Access Compliance Report

Public Rights-of-Way

(Curb Ramps)

Intersection ID: 24112	Main Street: CARMEL_RD	Cross Street: CARMEL_VALLEY_RD	Location: SE
ADA ID: BA4A35E3E0D2	Ramp Type: Perp	Initial Pass/Fail: Fail	Overall Compliance: No
Severity Score: 33.75			
Codes/Mitigation Info/Possible Solution		Field Measurements/Component Compliance

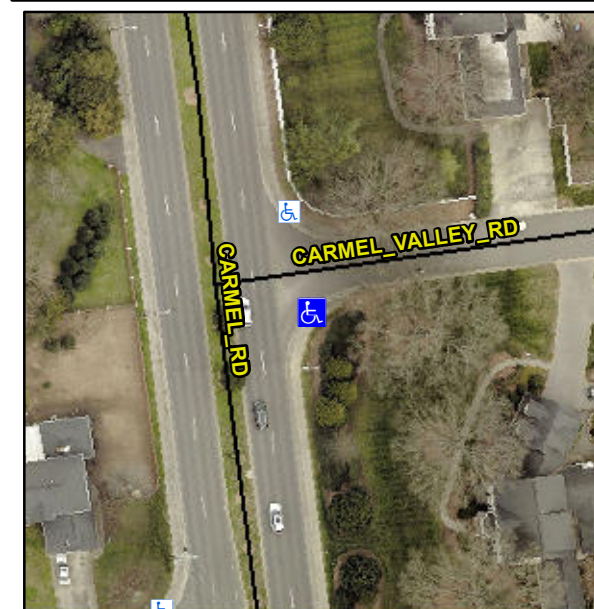
Not Found, R304.5.1, R304.2.2

Compliance	Description	Data	Compliance	Description	Data
N/A	Ramp Length (in)	59.0	No	Ramp Slope (%)	13.4
No	Ramp Width (in)	43.0	Yes	Ramp XSlope (%)	1.8
N/A	Flare Type LT	N/A	N/A	Flare Type RT	N/A
N/A	Flare Slope LT (%)	N/A	N/A	Flare Slope RT (%)	N/A
N/A	Flare Traversable LT?	N/A	N/A	Flare Traversable RT?	N/A
N/A	Landing Length (in)	N/A	N/A	DWS Provided?	N/A
N/A	Landing Width (in)	N/A	N/A	DWS Contrast?	N/A
N/A	Landing Slope (%)	N/A	N/A	DWS Length (in)	N/A
N/A	Landing X Slope (%)	N/A	N/A	DWS Full Width?	N/A
N/A	Landing Curb? (Y/N)	N/A	N/A	DWS Offset (in)	N/A
N/A	Shared Landing?	N/A			
N/A	Gutter Ponding?	N/A	N/A	Gutter Slope (%)	N/A
N/A	Gutter Lip Ht (in)	N/A	N/A	Gutter X Slope (%)	N/A
N/A	Painted X Walk1?	No	N/A	Painted X Walk2?	N/A
	X Walk 1 Direction	To N		X Walk 2 Direction	N/A
N/A	X Walk 1 Width (in)	N/A	N/A	X Walk 2 Width (in)	N/A
	X Walk 1 Slope (%)	0.5		X Walk 2 Slope (%)	N/A
	X Walk 1 X Slope (%)	2.0		X Walk 2 X Slope (%)	N/A

Remove & Replace Entire Ramp.
